CASE: MR-1930F

MANDATORY REFERRAL REVIEW

PROPOSED WMATA REGIONAL OFFICE BUILDING

THE PRINCE GEORGE'S COUNTY PLANNING DEPARTMENT

CIRCULATION PLAN

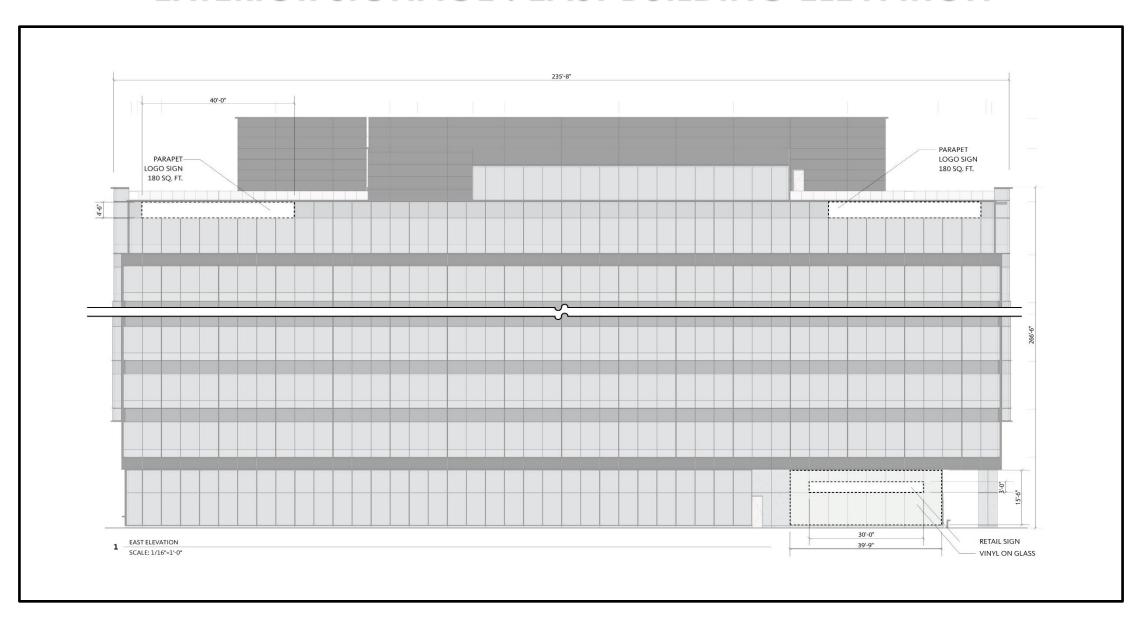
WMATA should provide additional bicycle racks at the new building. As a leader in regional transportation services, WMATA has a great opportunity with this high-visibility project to provide and showcase urban design elements and amenities that encourage multimodal transportation at the New Carrollton Metro Station.

BUILDING PLAZA PLAN

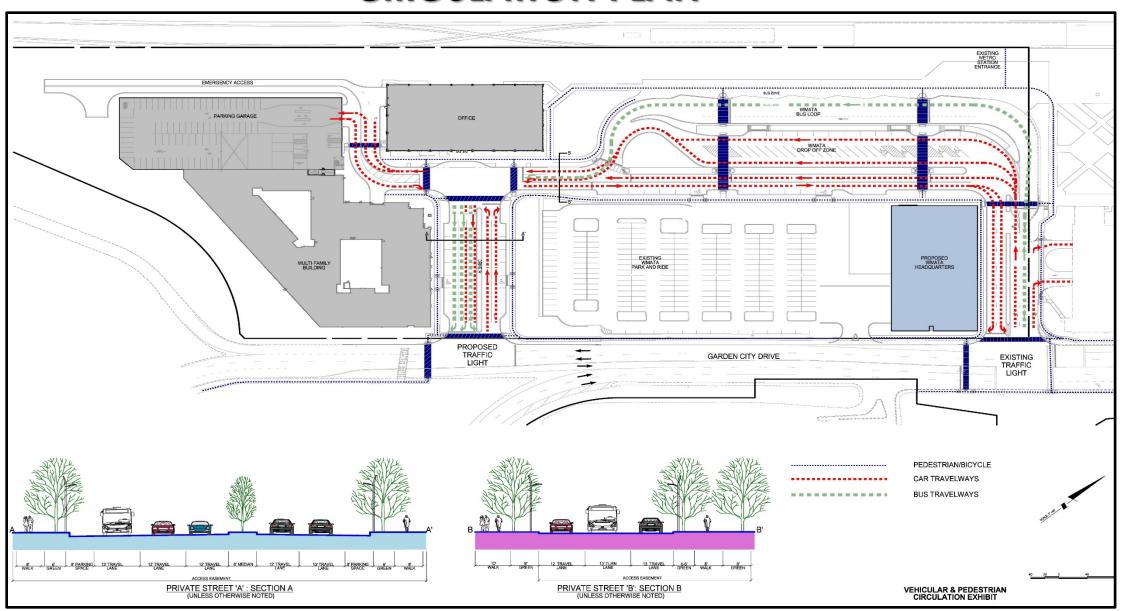
WMATA should provide additional design details to show how the public plaza and building loading and service area will be appropriately separated and screened.

The applicant should provide additional site amenities such as bicycle repair stations, water bottle filling stations, or art sculptures in the public plaza and streetscape surrounding the building.
